FILE NUMBER: S223-142

REQUEST: An application to replat a 2.037-acre tract of land containing all of Lot 5B in City Block W/8751 to create one 0.827-acre lot and one 1.210-acre lot on property located on Frankford Road, west of President George Bush Turnpike.

STAFF RECOMMENDATION: The request complies with the requirements of the CR Community Retail District; therefore, staff recommends approval of the request subject to compliance with the following conditions:

TOMMY CAR
WASH ADDITION
 LOTS 1 AND 2, BLOCK W/ASH
 BEING A BEHAVIAT 09/10/17 A. BLOCK W/ASH
 MAKAMY CHERRING SHOWING CENTER III - PHASE I
 WILLIAM MILLER SUBDIVISION, CONTRACT NUMBER 885
 CITY OF TOTTALAH, TENNESSEE
 CITY PLAN FILE NO. 2023-142
 CITY ENGINEER: MANN FILE NO. DP22451

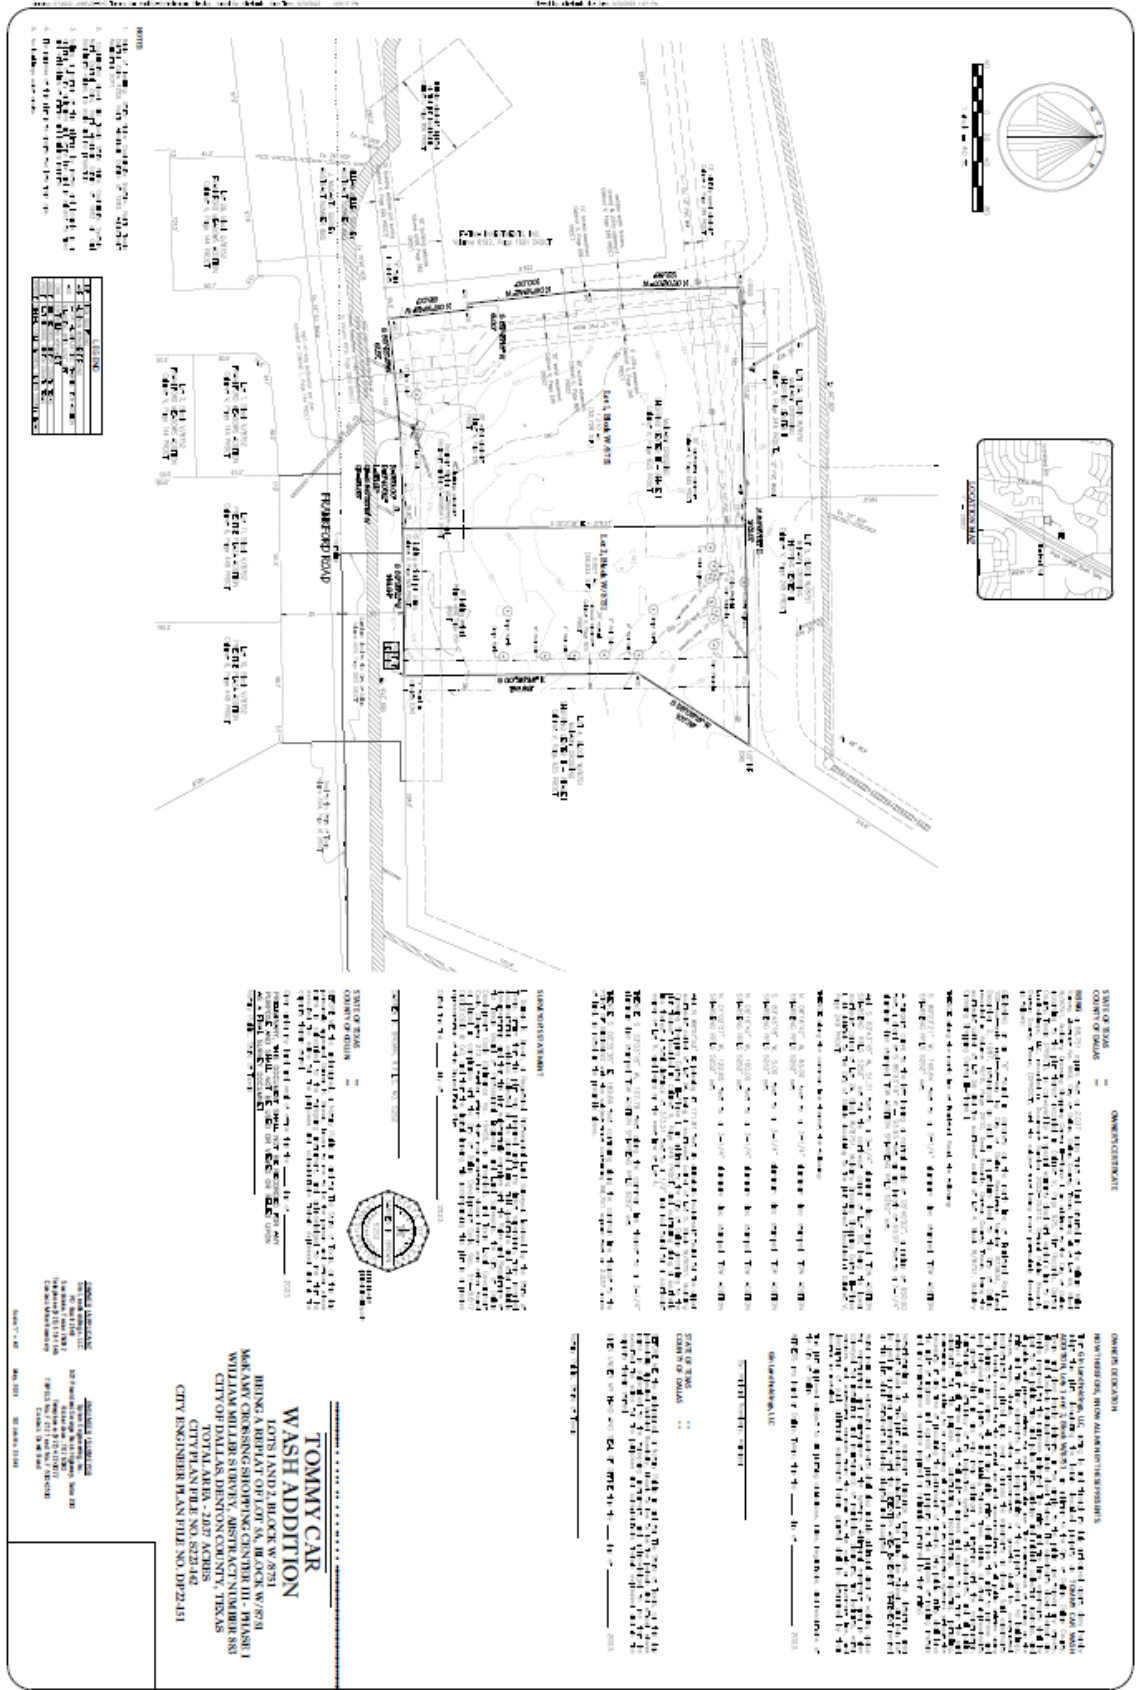
5. Any new or existing structure may not extend across new property lines. *Section 51A-8.503(e)*
6. On the final plat, all easement abandonments, and ROW abandonments must be by separate instrument with the recording information shown on the face of the plat. A release from the Real Estate Division is required prior to the plat being submitted to the Chairman for signature.

7. On the final plat, include two boundary corners tagged with these coordinates: "Texas State Plane Coordinate System, North Central Zone, North American Datum of 1983 on Grid Coordinate values, No Scale and no Projection."

8. On the final plat, monument all set corners per the Monumentation Ordinance. Prior to submittal of the final plat for the Chairman's signature. The monuments must be verified by the Chief City Surveyors Office in the Public Works Department. *Section 51A-8.617*

19. Additional design information is required for assessment. Site plan must be submitted showing proposed development, building finished floor elevation, development, existing mains – including downstream manhole, and proposed water and wastewater service locations. Submit water/wastewater engineering plans to 320 E. Jefferson Blvd., Room 200, Attention: Water and Wastewater Engineering.
20. Water and wastewater main improvements may be required by Private Development Contract. Submit water/wastewater Engineering Plans to 320 E. Jefferson Blvd., Room 200, Attention: Water and Wastewater Engineering.

22. On the final plat, identify the property as Lots 5C & 5D in City Block W/8751. Ordinance 1A, Page 131 pages 131-148, Section 2 (passed August 13, 1872).
